ARCOS BULLETIN 2015-1

SUBJECT: IT Design

### IT Design and Construction Criteria Updates

Last Updated: 9 March 2015

A1 STANDARD TELECOMMUNICATIONS SYMBOL LEGEND

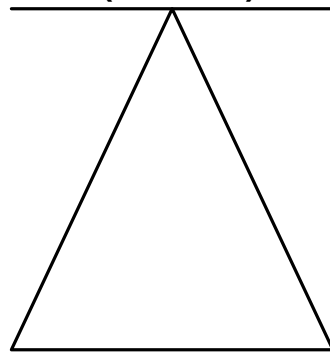
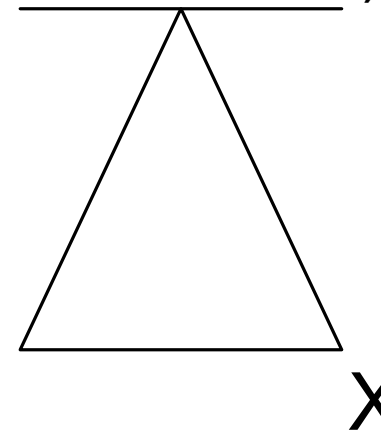
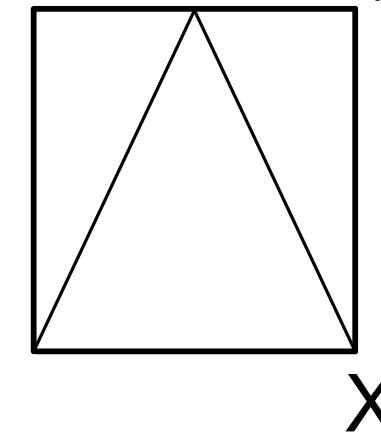
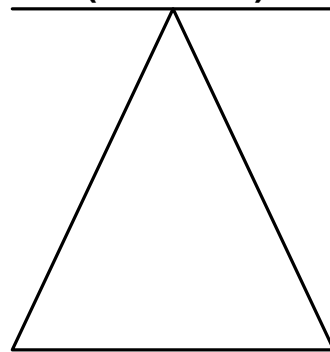
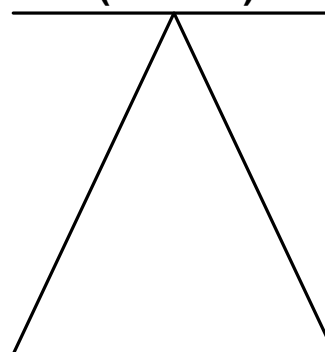
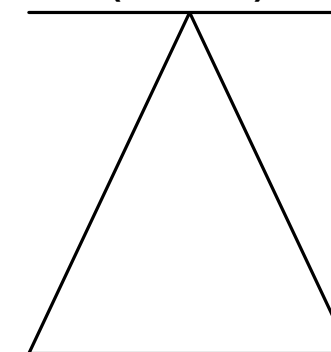
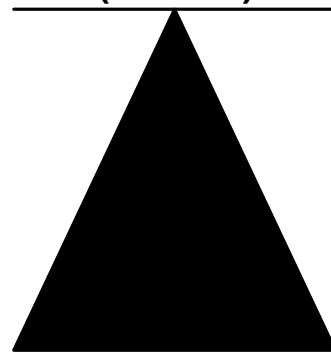
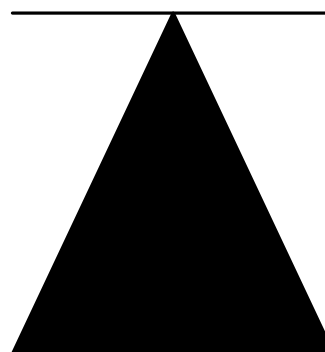
- 4.2.11. USARC G-6 has developed a Standard Telecommunications Symbols Legend. This legend is required to be used as the basis of design for the IT DOR's Telecommunications Symbol Legend. See Section 5 Diagrams for further clarification

A1 TYPICAL TER IT RACKS COMPONENTS FRONT VIEW

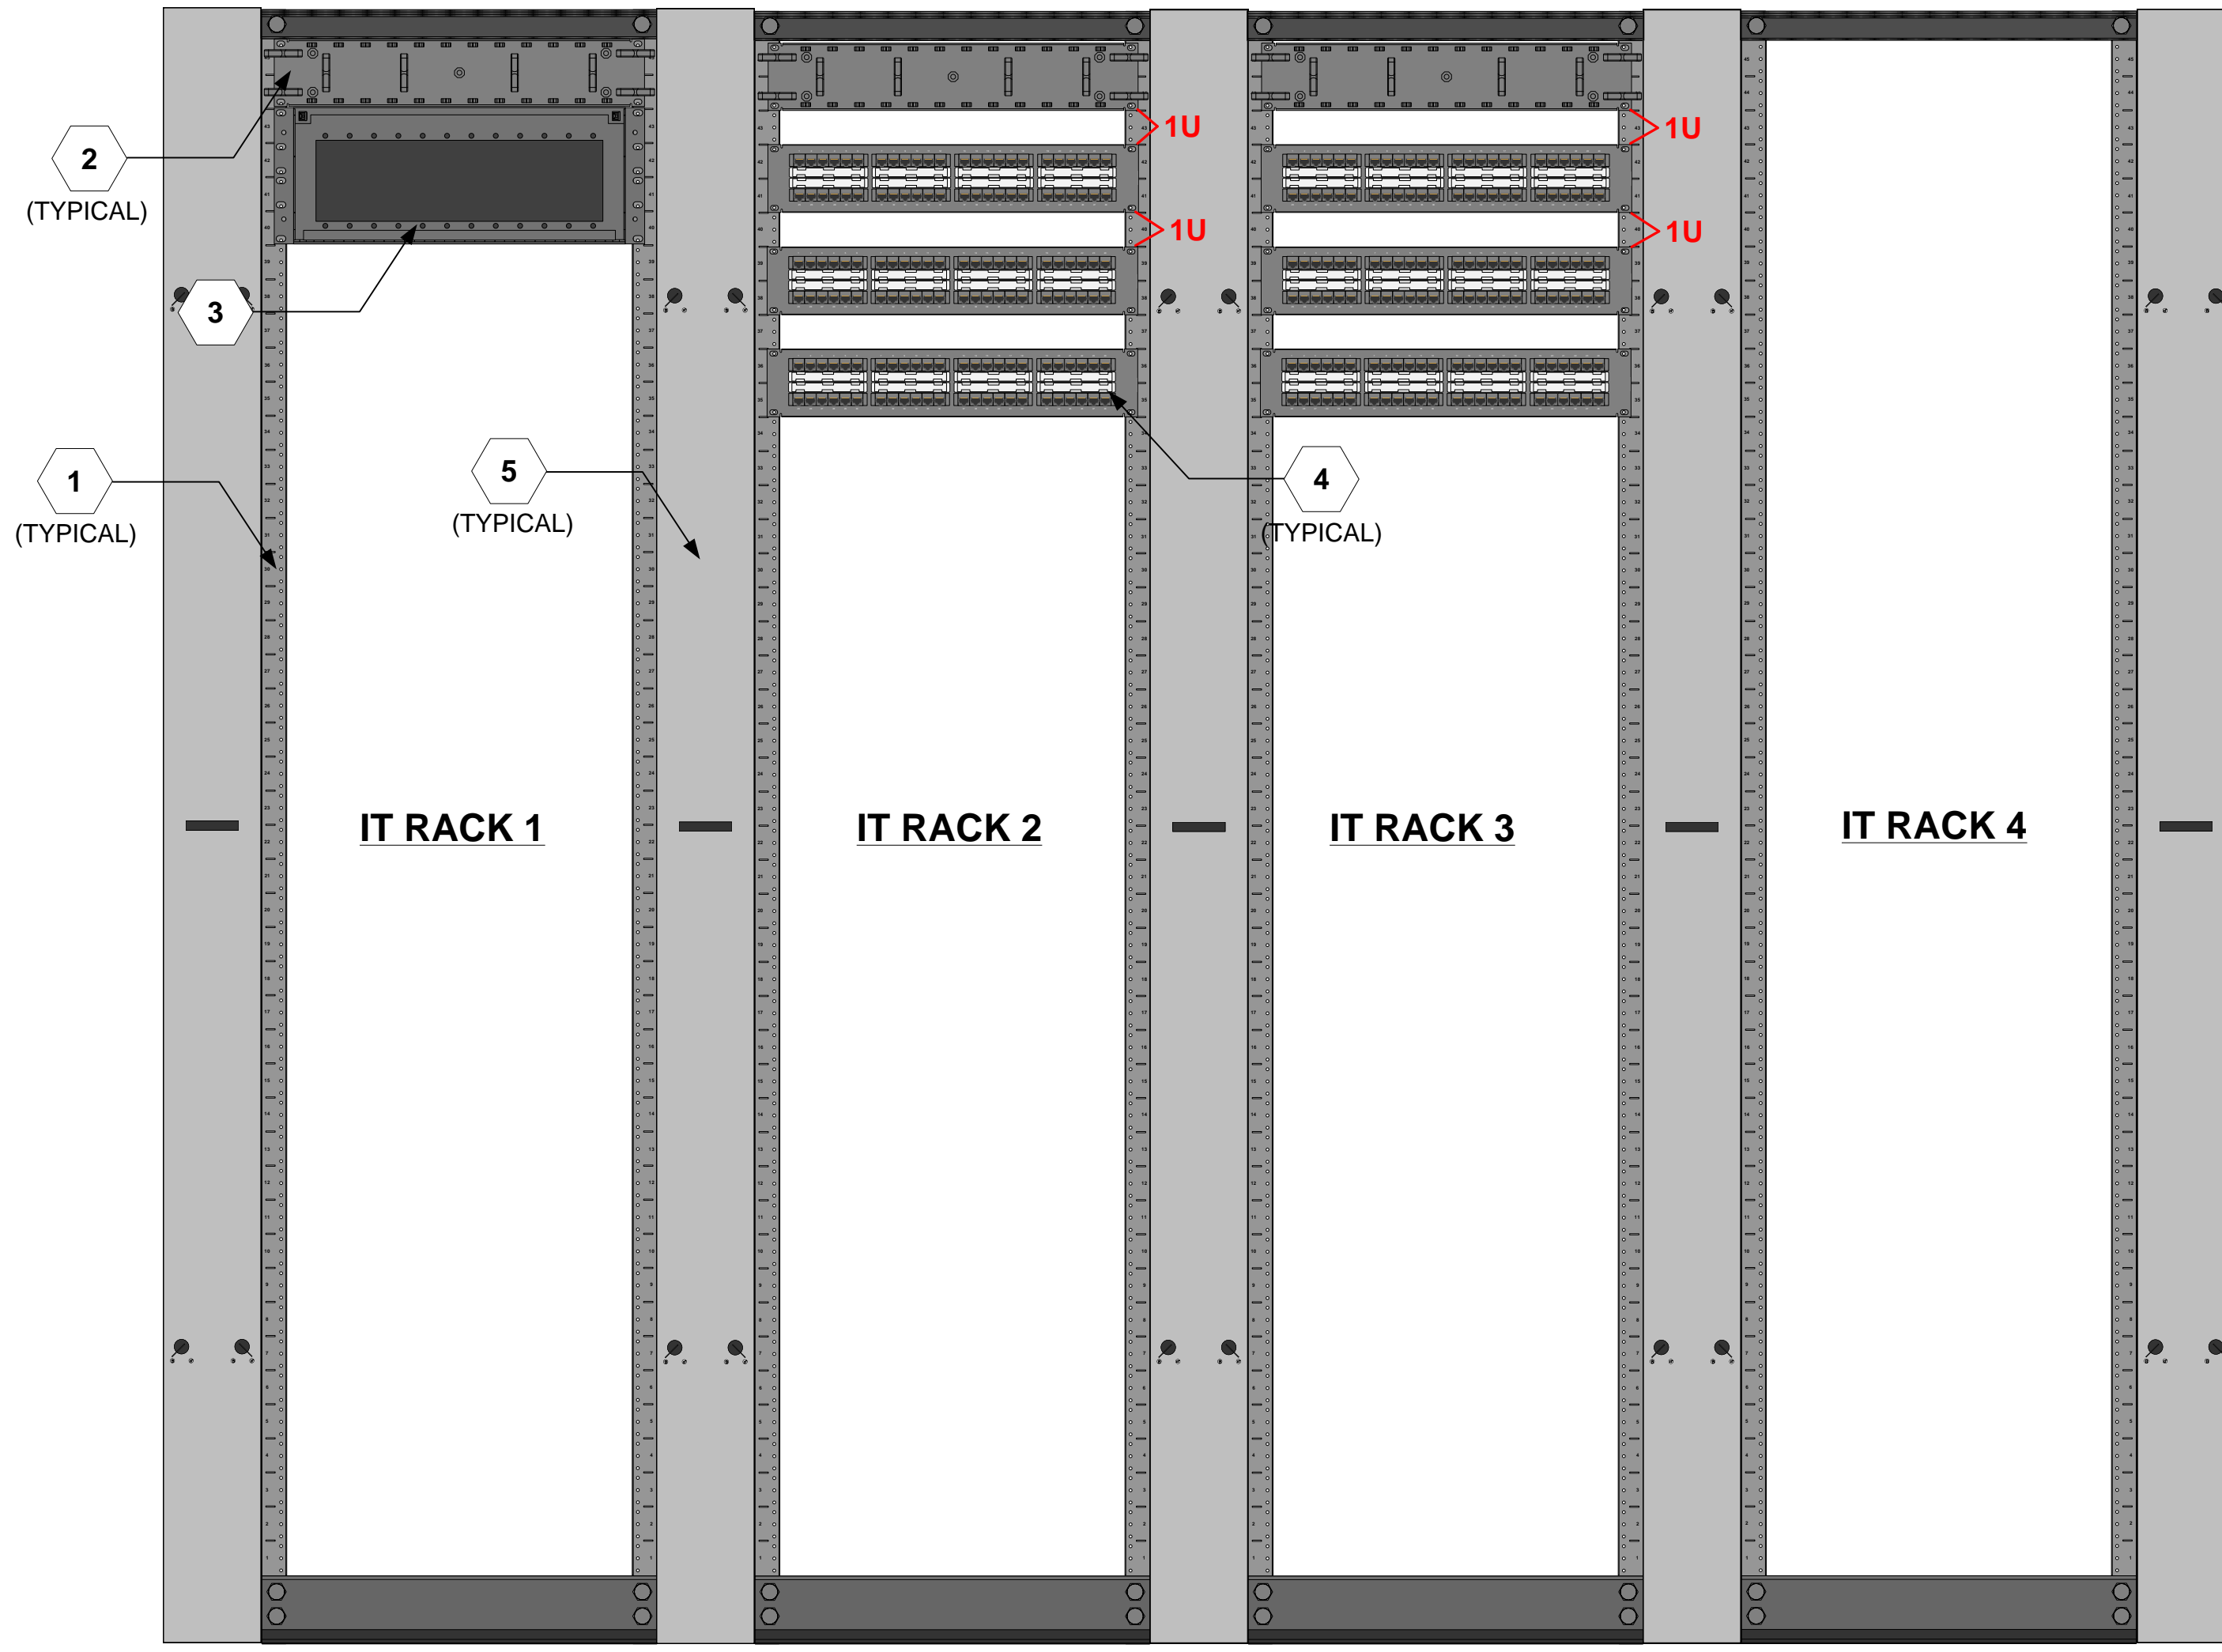
- 4.1.4. All horizontal category 6 cabling will now be terminated IAW the T568B pin-out.
- 4.1.5. The top and bottom 2U horizontal wire manager in all IT racks are no longer required. See Section 5 Diagrams for further clarification

A1 TYPICAL TER IT RACKS COMPONENTS REAR VIEW

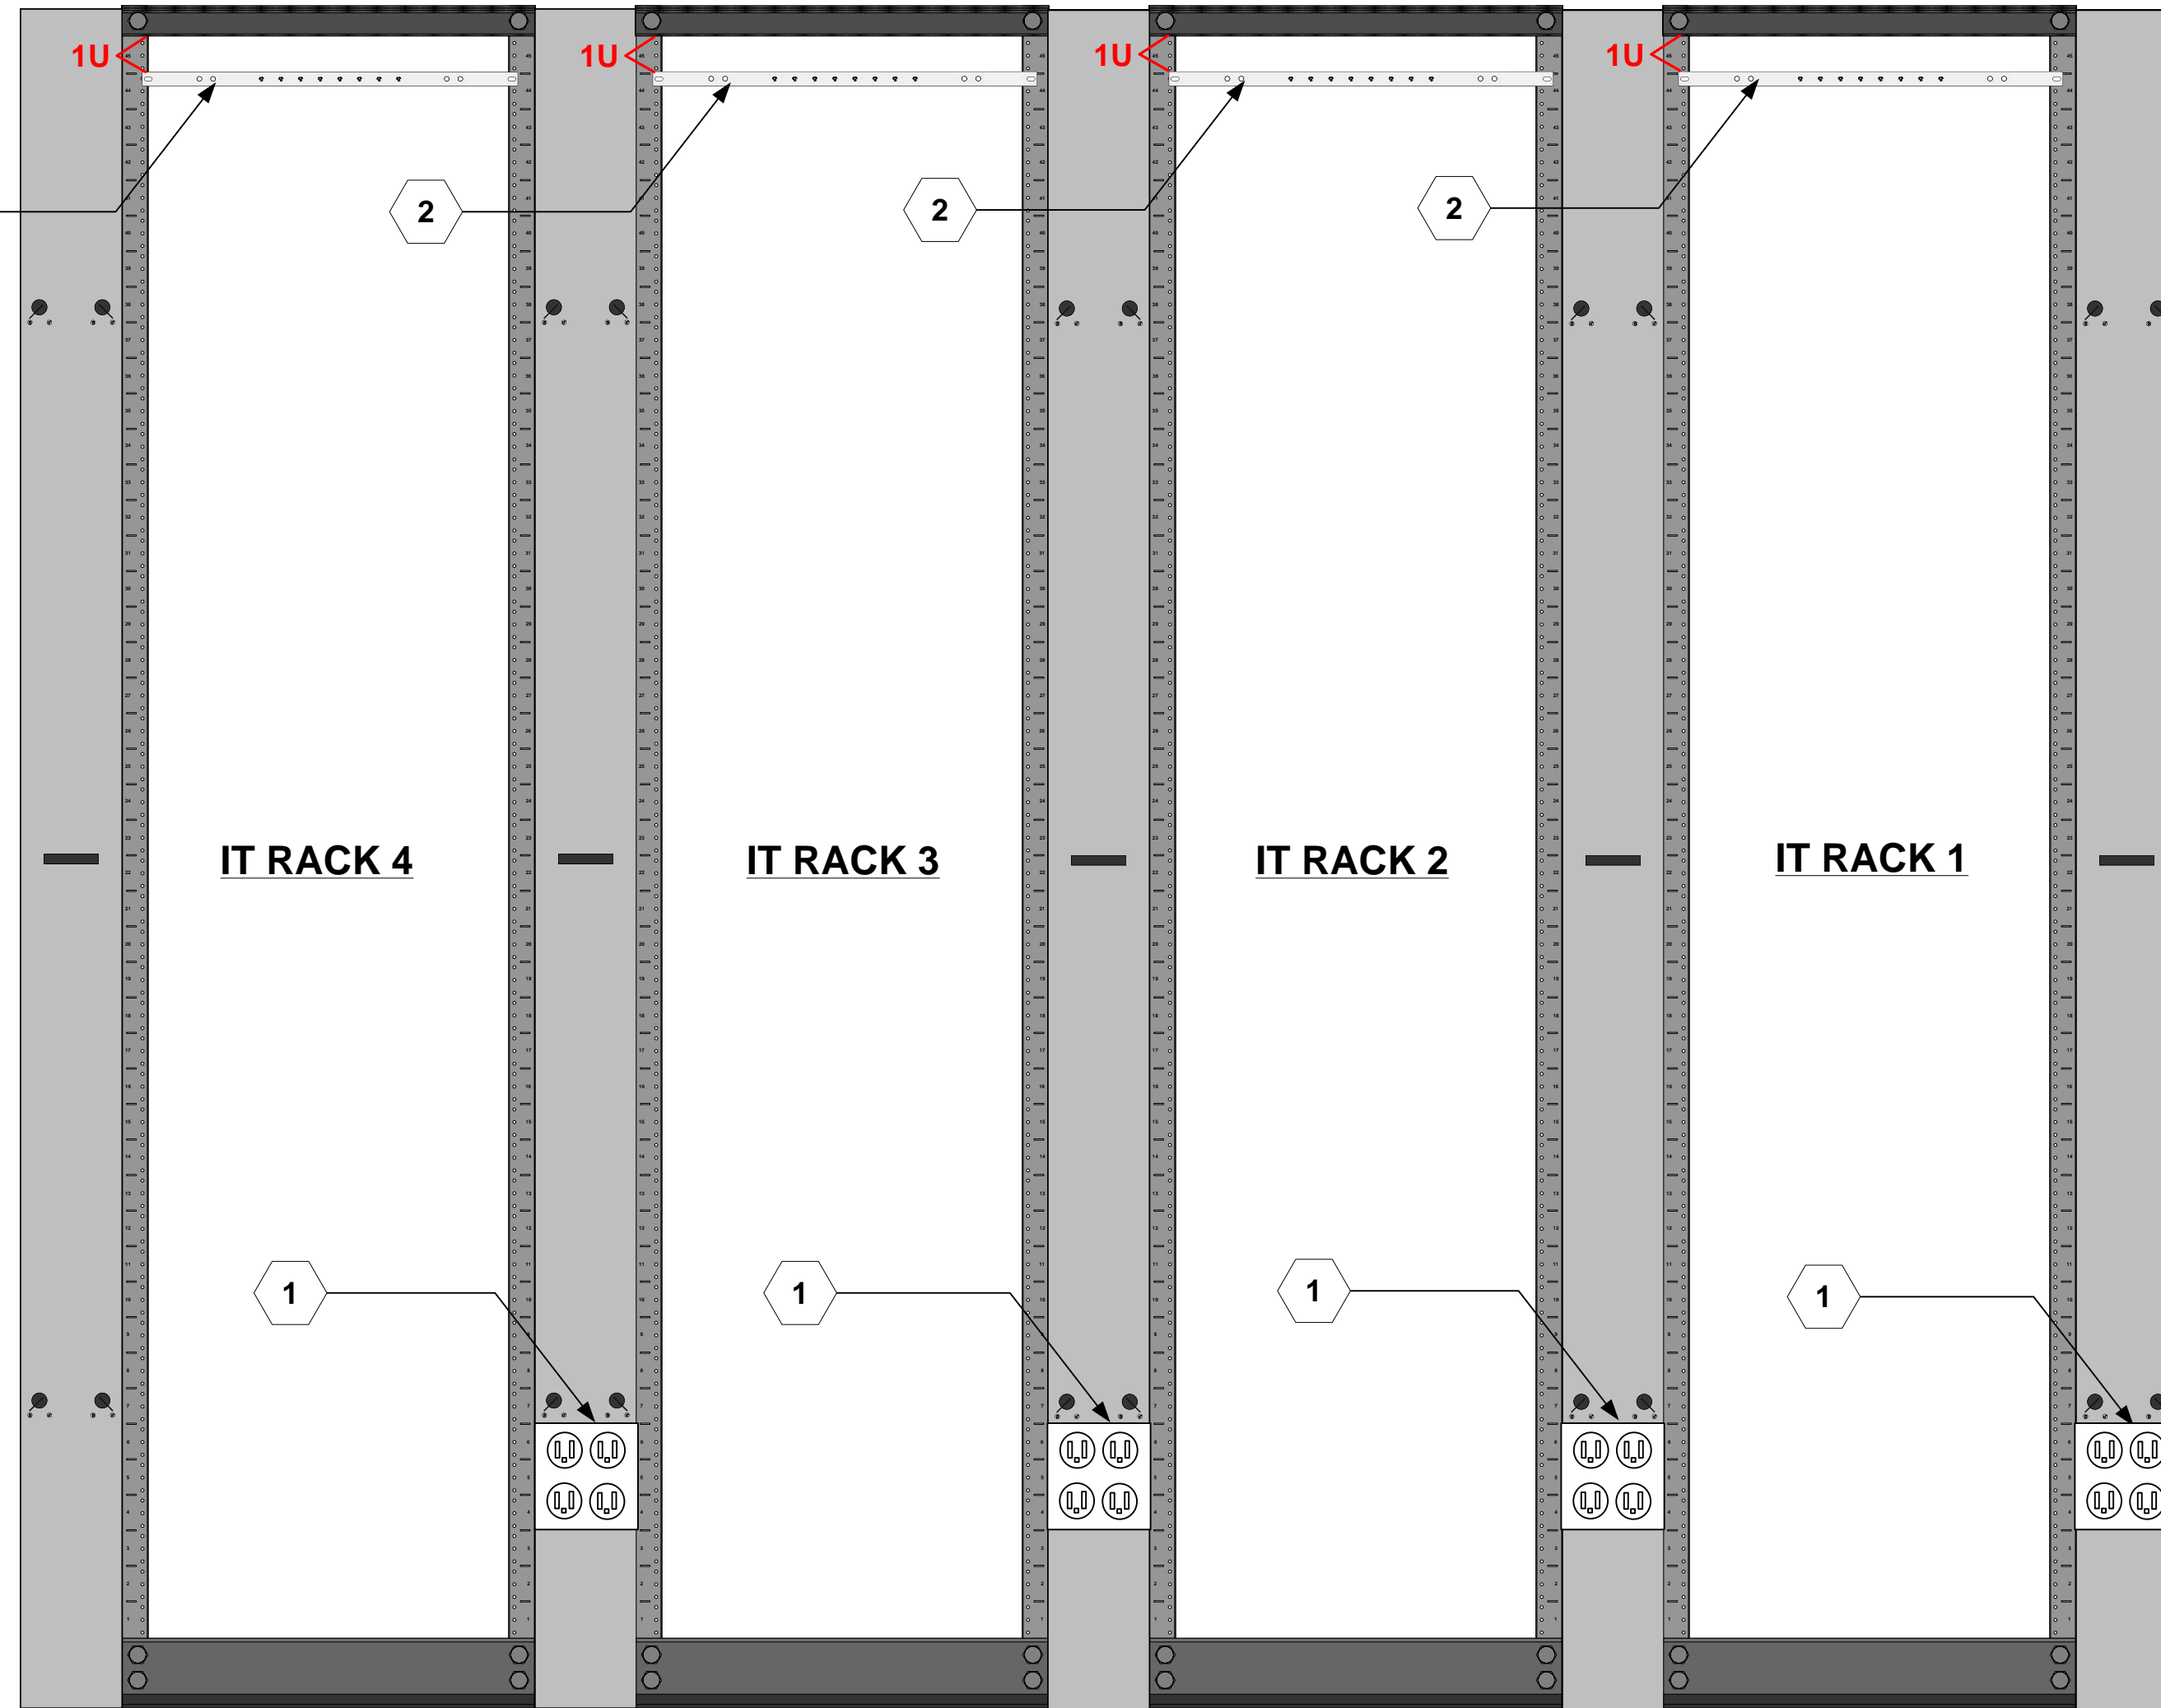
- 4.1.8.2. Per requirements adopted in ANSI/TIA-607-B a rack-mounted horizontal TGB must be added to each IT rack. Locate this rack-mounted horizontal TGB at the top rear of the rack. See Section 5 Diagrams for further clarification

- 4.2.14.1.3. TER and all TR(s) - New requirements call for one dedicated 120V/20 Amp circuit with one double duplex NEMA 5-20 receptacle for each 19 inch (480 mm) rack or cabinet in the TER and all TR(s). This receptacle shall be mounted 15" AFF on the rear of the rack.
